Narrative Testimony for the M3 Eagle Water Right Application

Dennis Owsley

May 11, 2009

This narrative testimony was developed in response to the April 1st memo prepared by HLI in response to our March 2nd Staff Memorandum. I co-authored the March 2nd Staff Memorandum and appreciate this opportunity to provide testimony in response to the comments provided by HLI in the memo.

Exhibit 33T

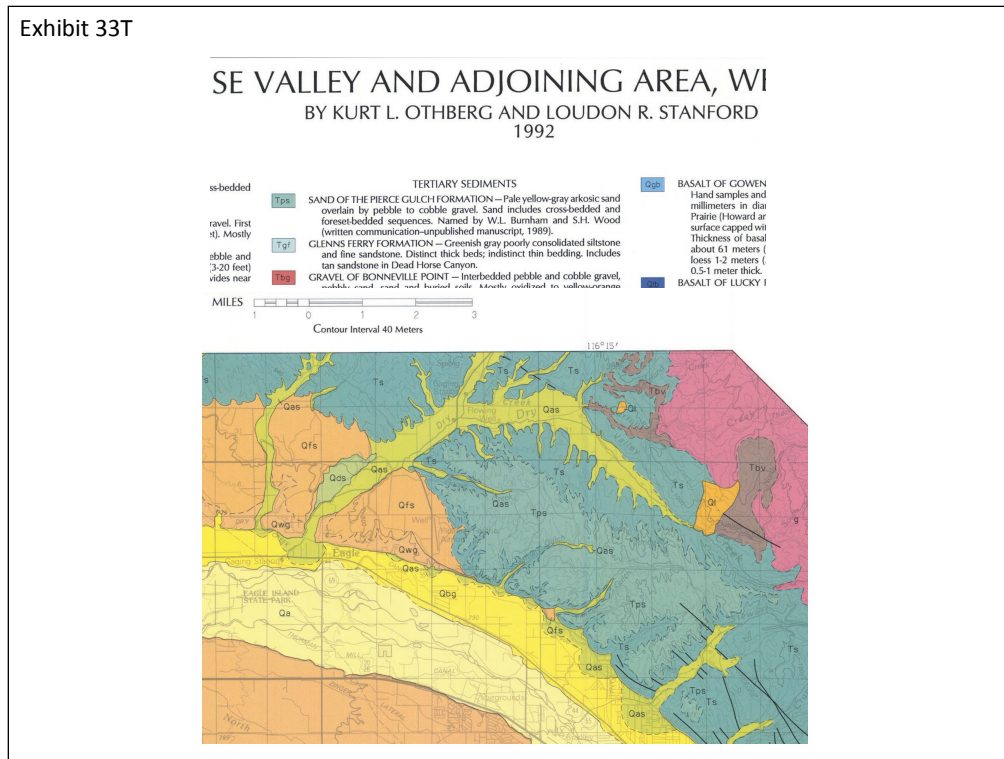
These two images are clips are from the geologic map included by M3 in the submittal of supporting documentation for this water right (Exhibit #33T). We referenced this map when describing the Pierce Gulch Sand in our staff memo. In response to our description and citation of this map, HLI states on page 3 of Exhibit 45

The staff referenced the Othberg and Stanford map as it was the only published geologic map submitted in support of this water right. The PGS is shown as an outcrop on this map and is specifically defined in the legend of this map.

Again, the staff referred to the PGS as a Formation based on the description on the geologic map HLI provided to the department. In addition, it is inconsistent for HLI to claim the Pierce Gulch Sand is not a Formation, when we heard Dr. Wood's April 24th testimony referring to the Pierce Gulch Sand as a formation.

Figure 4

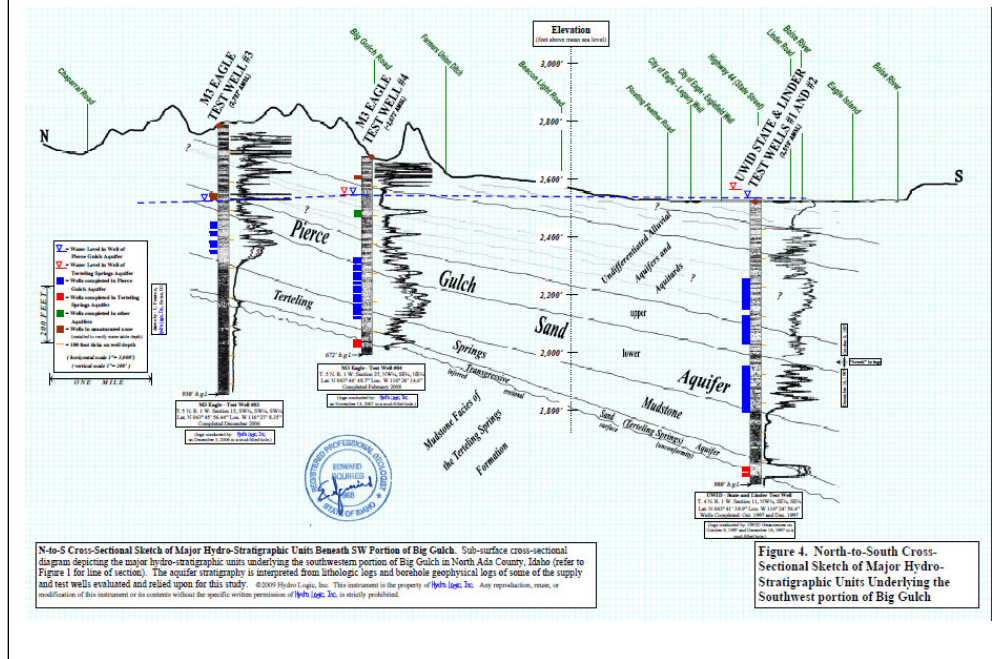
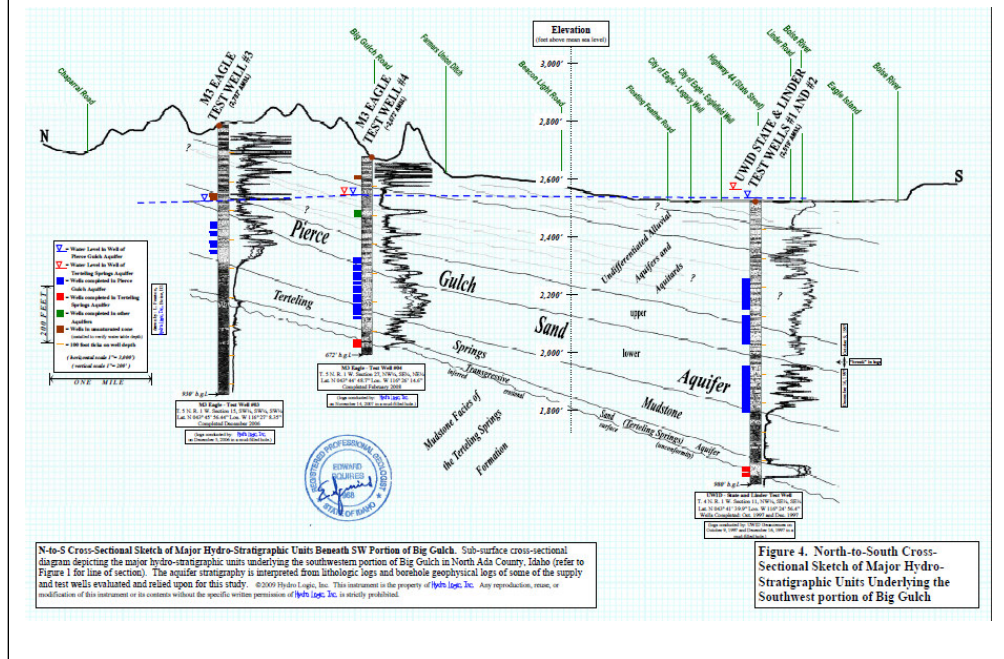
The base of the aquifer is one of the two boundaries that HLI states they have currently defined. However, Figure 4 of Exhibit 44 does not indicate the base of the aquifer is fully defined beneath the M3 property. For example, look at Test Well #4, specifically at the lower completion of the well. Terteling Springs Mudstone is drawn through the bottom of the aquifer in this well. Test Well #3 and Test Well #4 are the two wells in which we heard Mr. Squires testify that they had “{QUOTE} great certainty”{END QUOTE} in the correlation of geologic units between them. Even with what is considered ‘*great certainty*’ in correlating units under the M3 property using the high quality borehole data that exists on the property, some inferences and interpretations must be made to correlate the geologic units. These interpretations get larger as you move further away from the M3 property due to the lack of high quality borehole data.

This is the same slide again, however, I would like to point out two additional items related to this slide. First is the identification of the target aquifer in the UWID State and Linder Test Wells. The top of the Pierce Gulch Sand Aquifer in this picture is hard to distinguish in the geologic and geophysical logs between what is identified as the overlying “Undifferentiated alluvial aquifers and aquitards.” The fact that a screened portion overlaps the boundary line drawn further supports this observation.

The depiction of the thickness of the Pierce Gulch Sand Aquifer in this figure is inconsistent with other HLI documents. For example, Exhibit 12, The Re-Analysis of 16 Aquifer Tests Report, identified the Pierce Gulch Sand to be 525 feet thick at this location. However, this figure shows the Pierce Gulch Sand Aquifer to be only approximately 300 feet thick at the same location.

These inconsistencies create challenges when trying to distinguish the Pierce Gulch Sand Aquifer from the “undifferentiated alluvial aquifers and aquitards” that comprise the Treasure Valley aquifer system.

Figure 4

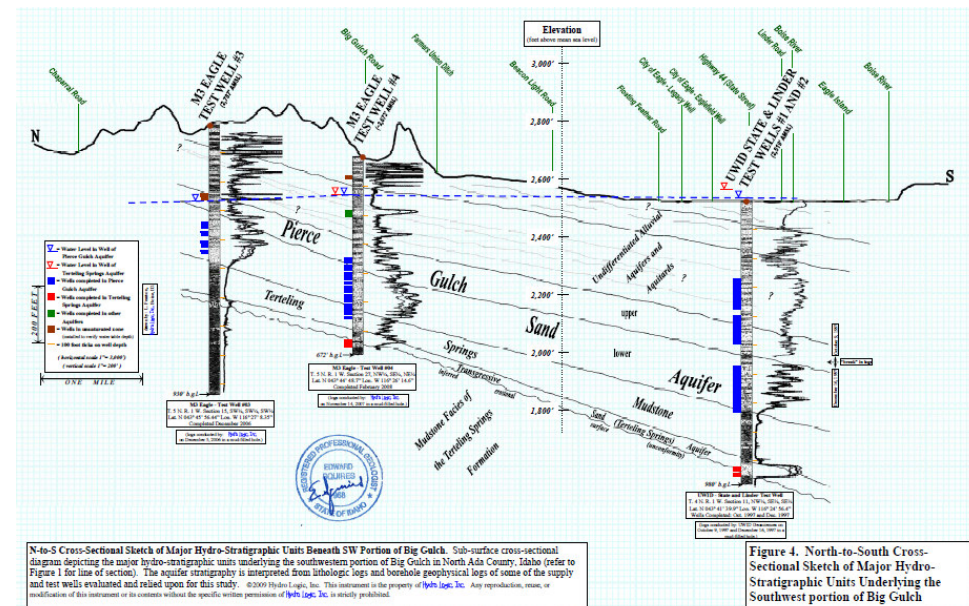
One last point with this slide, then we will move on.

Looking now at Test Well #3 and the completion intervals within it. The elevations of the saturated intervals of this well range from 2453 feet above mean sea level to 2,355 feet above mean sea level. Ground surface identified on this map near Linder Road and the Boise River is labeled at 2,518 feet above mean sea level. Therefore, the elevations of the water bearing zones in Test Well #3 are equivalent to the elevations of water bearing zones that are approximately 65 feet to 165 feet below the Boise River near Linder Road.

EXHIBIT 27

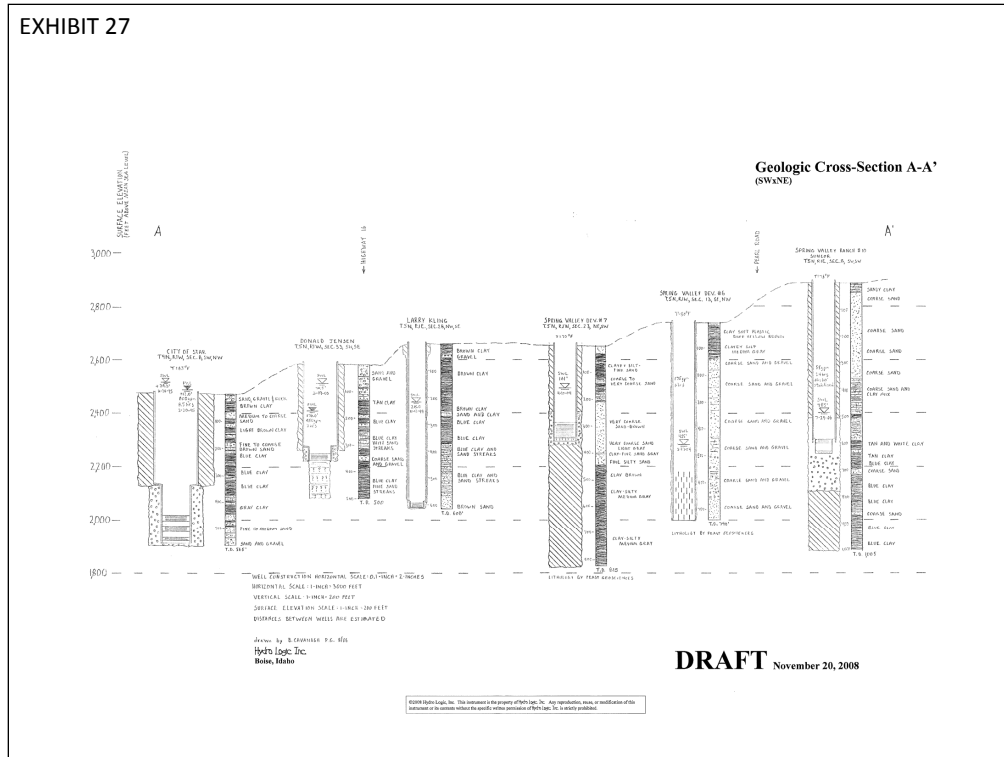
Some final comments I'd like to make regarding the stratigraphy of the area are related to the documents in Exhibit 27, titled Cross-sections of wells near M3 Eagle with well construction and lithology (thirteen total). On page 10 of Exhibit 45, HLI states :"*{QUOTE}M3 Eagle submitted 16 sub-surface cross-sections with its materials on November 26, 2008 and an additional four cross-sections on January 29, 2009.*" {END QUOTE} and continues with "*{QUOTE}It is unclear whether Staff evaluated the originally submitted 16; the Staff Memo does not discuss them. They are all significant to our analysis; and support our conclusions about the nature of the hydrogeology in this area and the lack of any PGSA-truncating faults here other than the WBE fault.*" {END QUOTE} I would now like to point out a few issues related to these submittals. This slide shows an example of one of the submitted figures in Exhibit 27. Note that there is no attempt in correlating geologic units between wells. All of the figures included in this exhibit are labeled draft with an original date of August 2006. Also, as we saw during this hearing, the map to accompany these diagrams was not presented until half-way through this hearing. These diagrams were not previously reference in any HLI authored documents prior to Exhibit 45. In addition, these diagrams were not previously available to the Department, although they are dated back in 2006.

Figure 2. Subsurface Seismic Reflection Profiles (from Wood)

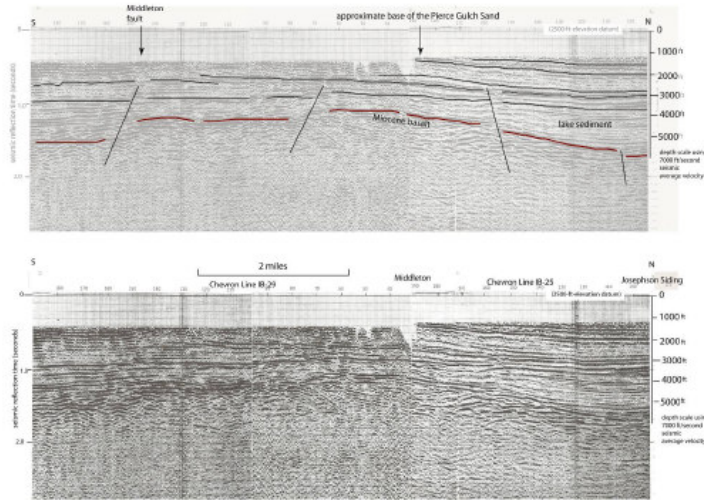
This figure is Figure 2, from Exhibit 45. As Mr. Vincent pointed out in his testimony, the upper 1,000 feet of data for these profiles is not provided, limiting the use of this data to make assumptions regarding the upper 1,000 feet.

We have heard testimony that geologic surface features in the area are rare, limiting the ability to identify or map faults at the surface. We have also heard testimony that wells logs can not indicate the presence or absence of faulting. Considering the seismic survey attempted by BSU on the M3 property was unsuccessful, it appears no data has been collected to support the lack of any faults that may be present in the upper 1,000 feet of the sedimentary section.

In conclusion, there is currently no research that has been conducted to confidently rule out the presence of faults in the upper sedimentary sequence. If faults do exist, they may play an important role in ground water flow in the area. They could serve as either conduits or flow barriers depending on the absence or presence of fault gauge. Or, more importantly in my opinion, could offset sedimentary units, increasing the hydraulic connections between different strata and reducing the hydraulic connection within the same strata.

Figure 1 (Zoomed in
on M3 Property)

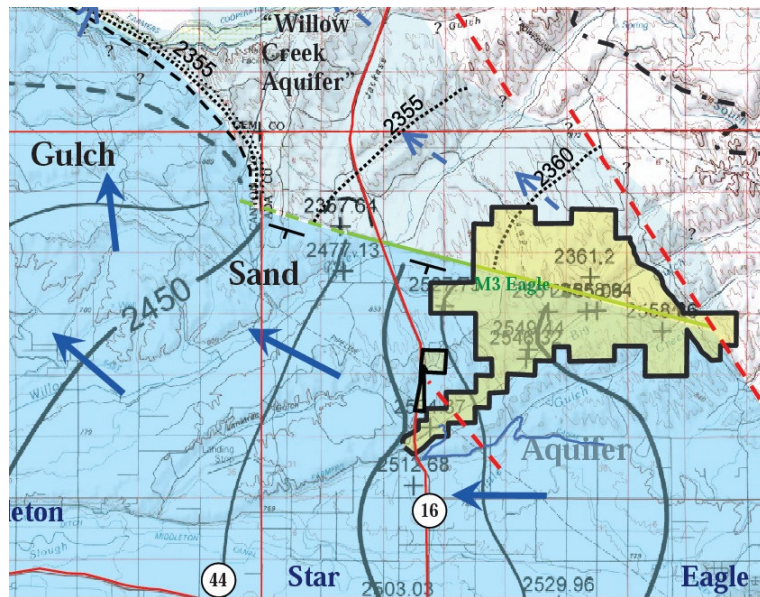
This is a zoomed in image of the previous slide focused in on the M3 area that contains the majority of the data points plotted on the regional map. The "green line" on the map represents a no-flow barrier and has significant importance on the ground water flow direction . Notice at the termination of the line the ground water flow abruptly changes to the north.

Exhibit 19

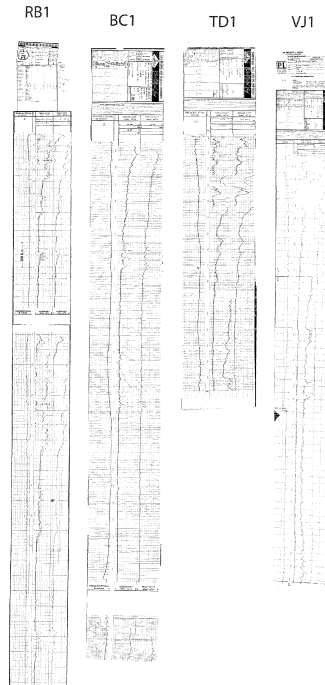
The second reason the Staff did not review the geophysical logs for the Daws and Johnson wells is because the logs were not properly identified and difficult to read. The slide shown here is are the geophysical logs as they were submitted to the department. Several issues made the review of these logs difficult. First it is unclear as to what the labels “RB1”, “BC1” “TD1, and VJ1 represent. Second, there was not a map to accompany these plots to show their location. And third, the legibility of the actual data on the plots was difficult to read.

The department was unaware of the significance of these plots until we read the April 1, 2009 memo from HLI.

Figure 7. Conceptual Profile of Pierce Gulch Sand Aquifer Between Boise and Payette Rivers

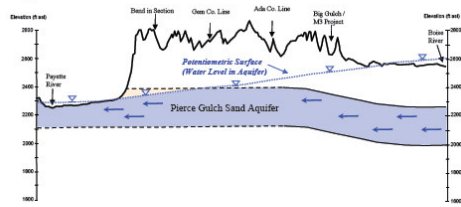
This slide shows the two hydrogeologic profiles of the Pierce Gulch Sand Aquifer submitted in support of this application that extend into the Payette basin. Although similar, the two profile lines are not in the same location. They do however, follow the general strike of the aquifer as define to the northwest. Therefore the change in dip can not account for the different depths of the Pierce Gulch Sand Aquifer beneath the Payette River. The differences between the two profiles suggests additional information is necessary to better define this aquifer on a regional scale.

Figure 24 **Figure 24. Cooper-Jacob Analysis for the Big Gulch Stock Well**

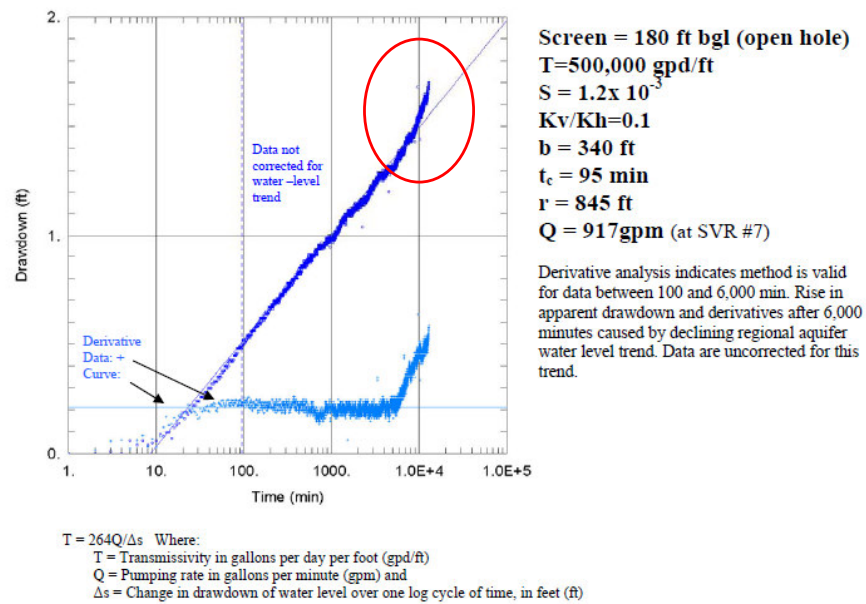
This slide is Figure 24 from Exhibit 44 showing the drawdown plot for the Big Gulch Stock well in the January 2009 submittal. The sudden increase at the end of the test raised questions for the Department and we commented accordingly in the staff memo.

Figure 6. Cooper-Jacob Analysis for the Big Gulch Stock Well with Water-Level Trend Corrections

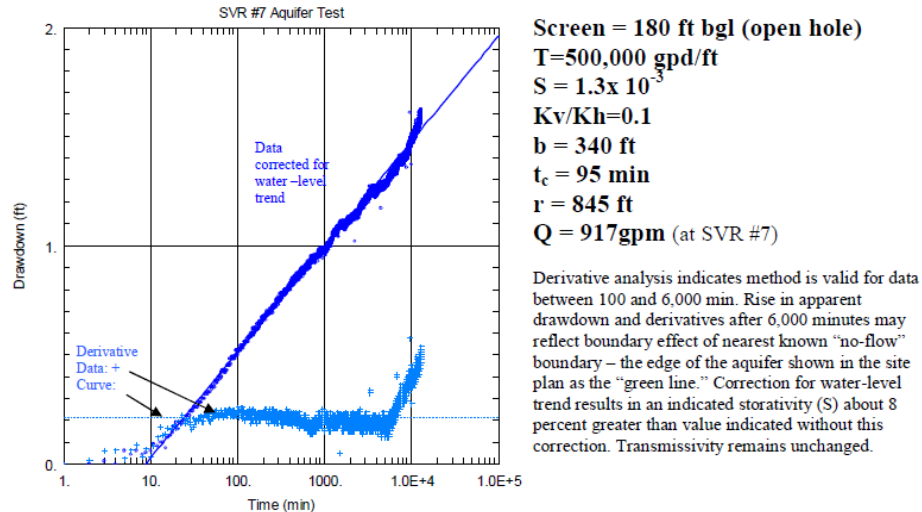
The presence of a hydraulic boundary is suspected by department and HLI. A test of longer duration would have provided additional information needed to determine the significance of such a boundary.

This is Figure 6 from Exhibit 45. HLI responded to our comments in the staff memo by correcting the drawdown data with the regional aquifer trend in attempt to account for the late rises in water levels. Note the increase is apparent in the corrected water levels as it was in the original submittal. In addition the text on the graph states "{QUOTE} Rise in apparent drawdown and derivatives after 6,000 minutes may reflect boundary effect of nearest know "no-flow" boundary – the edge of the aquifer shown in the site plan as the "green line.""{END QUOTE}

Figure 27. Theis Recovery Analysis for the Big Gulch Stock Well with Water-Level Trend Corrections

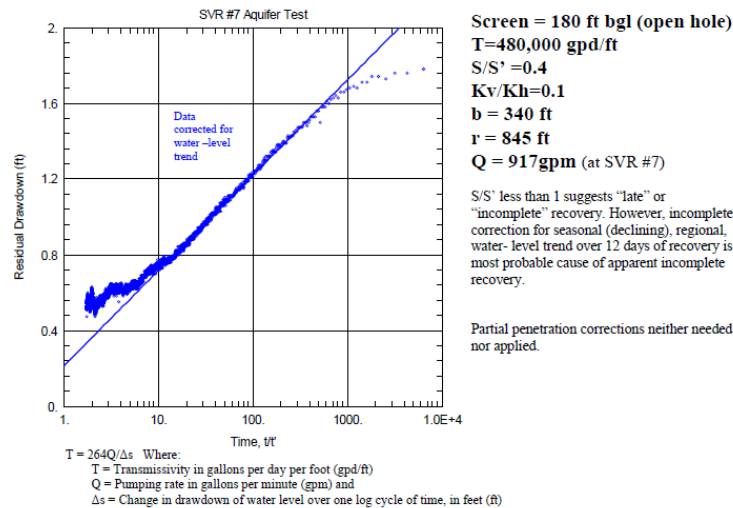
This slide is Figure 27 of Exhibit 44. This plot is a recovery plot of the Big Gulch Stock well. Note the deviation from the blue line on the left side of the plot. This deviation indicated an incomplete recovery in the water levels, meaning the water level did not fully recover to the pre-test level. Again, we commented accordingly in our Staff Memo.

Figure 7. Theis Recovery Analysis for the Big Gulch Stock Well with Revised Water-Level Trend Correction

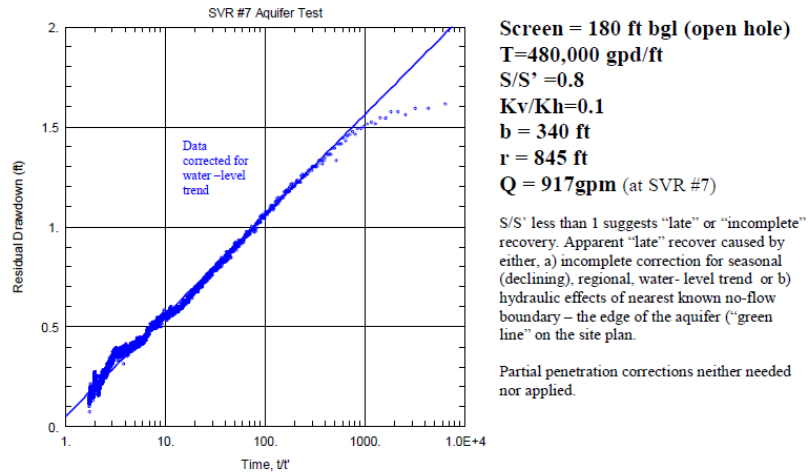
This slide is Figure 7 of Exhibit 45. HLI presented this plot in response to our comments regarding the lack of recovery. This is a plot of drawdown recovery data that was previously shown, but corrected for a trend that was misapplied to the data in the original submittal. Note this correction reduces the deviance from the straight blue line. The data also come closer to approaching full recovery. Possible reasons for the incomplete recovery are stated in the text of this plot that include: "{QUOTE} S/S' less than 1 suggests "late" or "incomplete" recovery. Apparent "late" recover caused by either a) incomplete correction for seasonal (declining) regional, water-level trend, or b) hydraulic effects of nearest known no-flow boundary – the edge of the aquifer (green line" on the site plan."{END QUOTE}

Figure 3

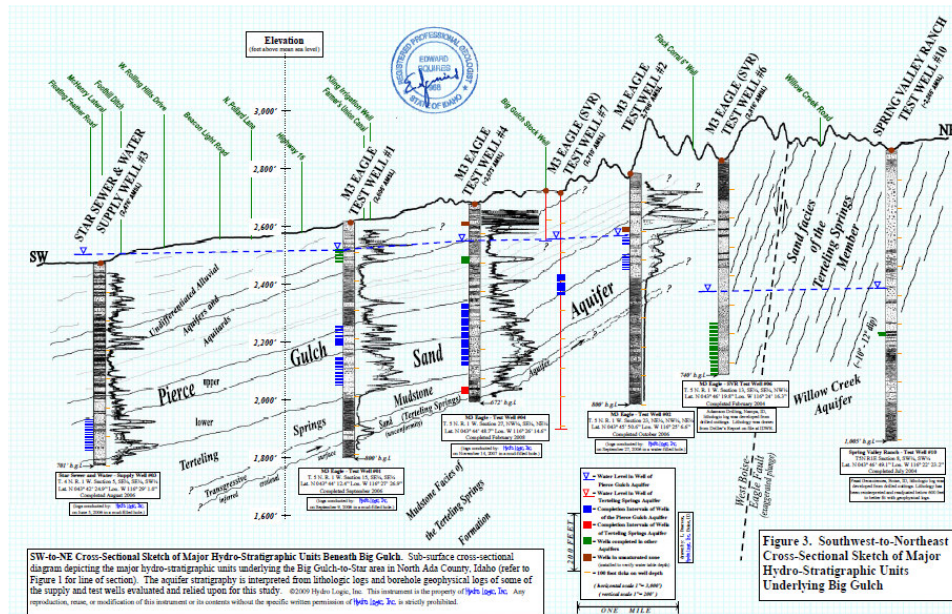
The “{QUOTE} green line” {END QUOTE} is one of the two boundaries that HLI states they have defined. As we heard in Mr. Vincent’s testimony, based on this figure it is unclear as to how the base of the aquifer can daylight on the west side of SVR #6. Additional questions are related to the water level fluctuations across the green line as it appears in this figure that permeable sediments could be in contact across the line.

FIGURE 3

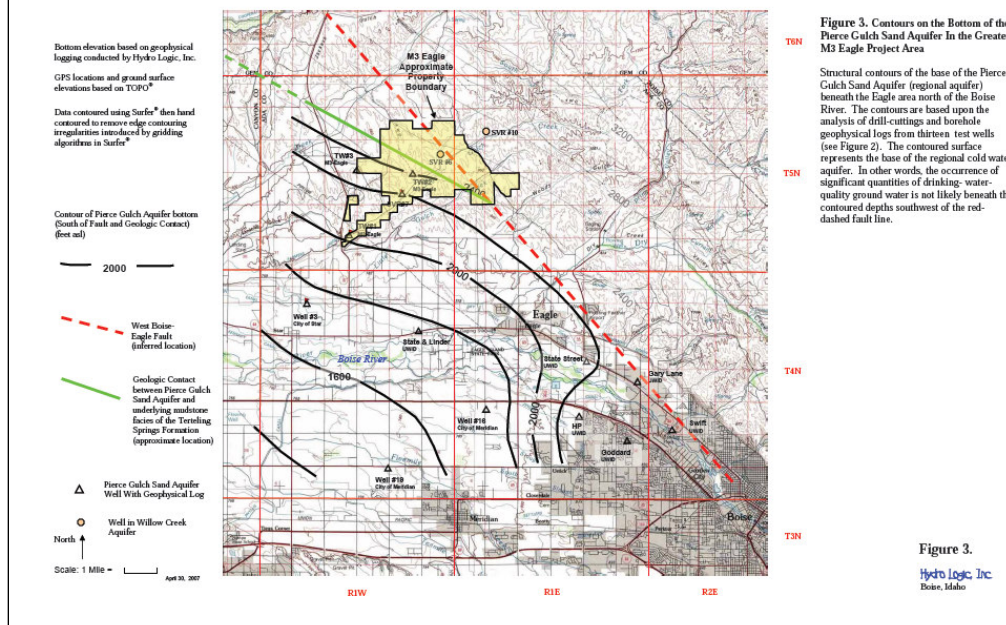
This slide shows figure 3 of the Exhibit 2. The map depicts the elevation contours in which represent the bottom of the aquifer. The bottom of the Pierce Gulch Sand Aquifer is considered equivalent to the top of the underlying thick mudstone. Equating the extent of the Pierce Gulch Sand Aquifer to the extent of the mudstone involves making the assumption that the sediments that directly overlie the mudstone are composed of deltaic sands. As I previously testified, the distinction between the Pierce Gulch Sand Aquifer and the undifferentiated alluvial aquifers and aquitards that exist throughout the region becomes less distinct with distance from the M3 property.
